RE: INSPECTION REPORT, COLOR COPY VIA EMAIL 4/27/06

We believe we have fully addressed the concerns you outlined in your Inspection Report dated April 18, 2006. You will find below items taken from your Report in italics, followed by my explanation of how we addressed them.

Picture 1: Hay Bales for Sediment Control

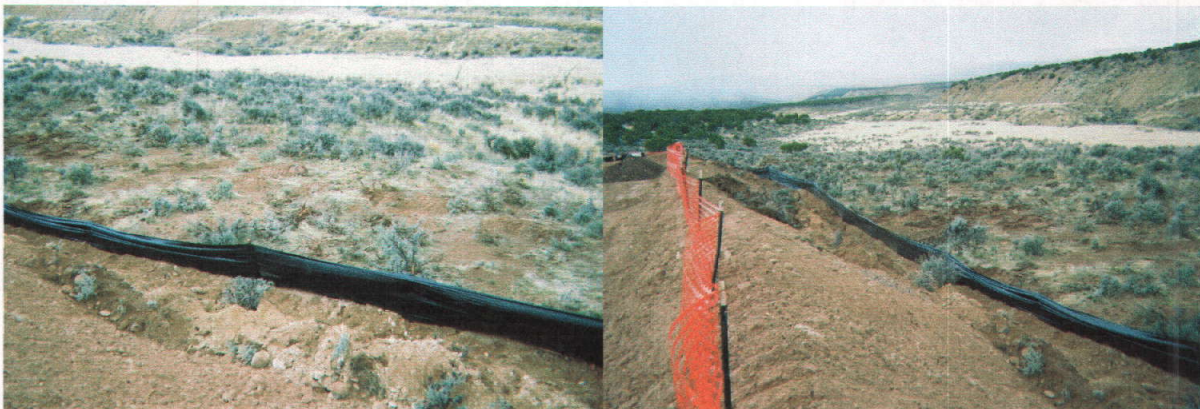
The site is graded such that all drainage would flow to the northeast or southeast corner. No sediment controls have been installed in these areas 9 (Photo 4).

We purposely graded the site to control the drainage, with a shallow ditch along the eastern side and north toward the nearest valley. We have now installed two rows of hay bales in the drainage ditch to slow run off from the site, thereby controlling and capturing any run off sediment. We have also installed silt fence along the entire northern berm of the site to control run off from the bermed area. And, finally, we place rip-rap at the far northern end of the drainage ditch to further slow any water running into the valley.
